ALAMO
COLLEGES
DISTRICT

ADDENDUM IV

**PURCHASE OF CONSTRUCTION SERVICES FOR SUNDANCE RENOVATION
AT NORTHEAST LAKEVIEW COLLEGE
RFP 2026-0080**

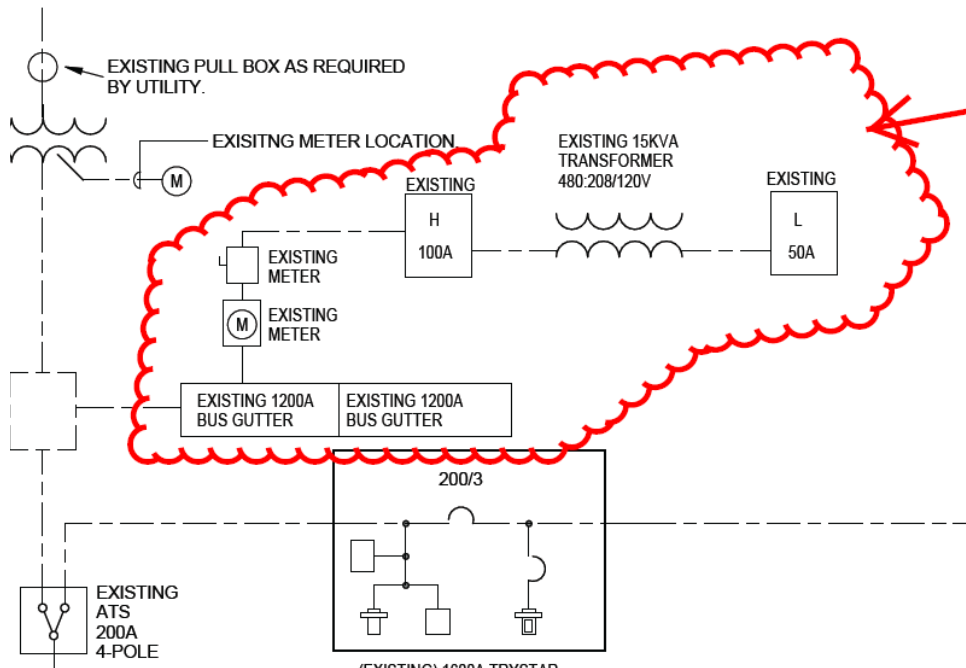
XXXVII. **QUESTION:** Plans and specs call out to have 2" DL track and CRC bridging to achieve deflection. Will Slotted Slip Track without using bridging be an acceptable alternative for deflection? (See detail 02/A-801 and spec description below)

ANSWER: Not an acceptable alternative.

02 PARTITION TYPES-STUD FRAMING TO DECK

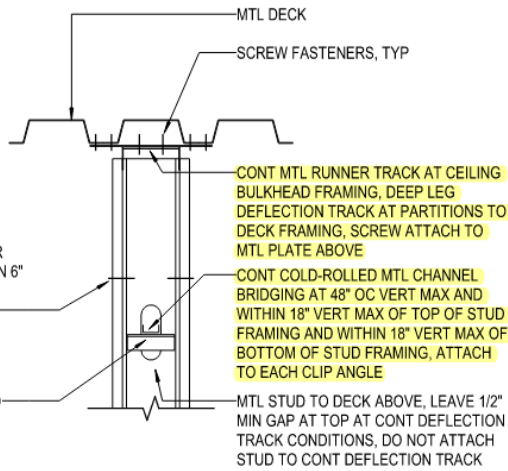
XL. **QUESTION:** Spec section 092116 -5 - 2.3 B-10. *Slip Type Head Joints: Where indicated, provide one of the following: a. Single Long Leg Runner System: ASTM C645 top runner with **2 inch** (50.8 mm) deep flanges in thickness not less than indicated for studs, installed with studs friction fit into top runner and with **continuous bridging**, located within 12 inches (305 mm) of the top of studs to provide lateral bracing.*

THIS DETAIL IS INTENDED TO SHOW THE STUD FRAMING CONNECTION TO DECK CONDITION AND BRIDGING INFORMATION ONLY AND DOES NOT SHOW OTHER ADDITIONAL INFORMATION, REFER TO PARTITION TYPES AND CEILING DETAILS FOR ALL OTHER MATERIALS, COMPONENTS, AND ASSOCIATED INFORMATION

ATTACH ANY BOARD ON EITHER SIDE OF STUD NO CLOSER THAN 6" MIN TO TRACK, REFER TO PARTITION TYPES

MTL CLIP ANGLE AT EACH STUD

MTL STUD TO DECK ABOVE, LEAVE 1/2" MIN GAP AT TOP AT CONT DEFLECTION TRACK CONDITIONS, DO NOT ATTACH STUD TO CONT DEFLECTION TRACK
